RE: Forest Lakes Bridges

COPIES	DESCRIPTION	CONTRACTOR
1	Pier Cap Rebar Shop Drawings	Structures

SHOP DRAWING REVIEW

- ☐ NO EXCEPTIONS ☒ REVISE AS NOTED
☐ REVISE AND RESUBMIT ☐ REJECTED

ELEVATION

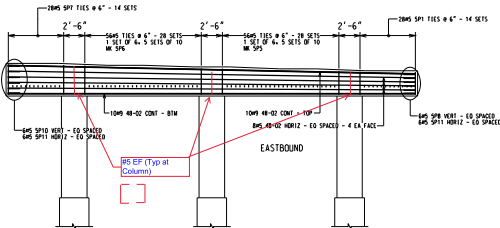
Add 6 #6s at the top of columns as shown in elevation comment
